<b>Subject:</b> VARIOUS AUDIO SYSTEM CONCERNS WITH TUNER AND AMP UNIT (TAU)	<b>Bulletin No:</b> 09-021/14
	<b>Last Issued:</b> 06/27/2014

2014 Mazda3 vehicles (with MAZDA CONNECT) with VINs lower than JM1BM\*\*\*\*\*194012 (produced before March 17, 2014)

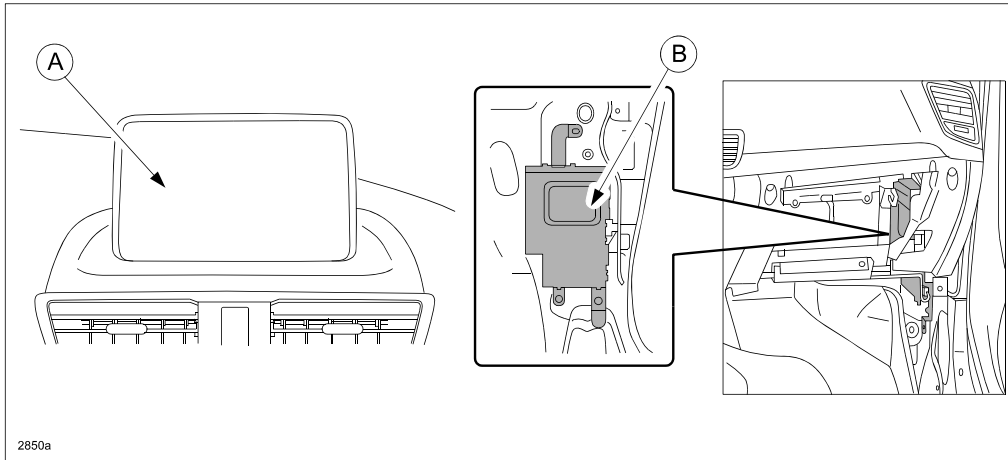
1. Verify customer concern.
2. On vehicle with a touchscreen (A), remove the TAU (B) and replace with a modified one. Refer to MS3 online instructions or Workshop manual (section 09-20 TUNER AND AMP UNIT (TAU) REMOVAL/INSTALLATION).
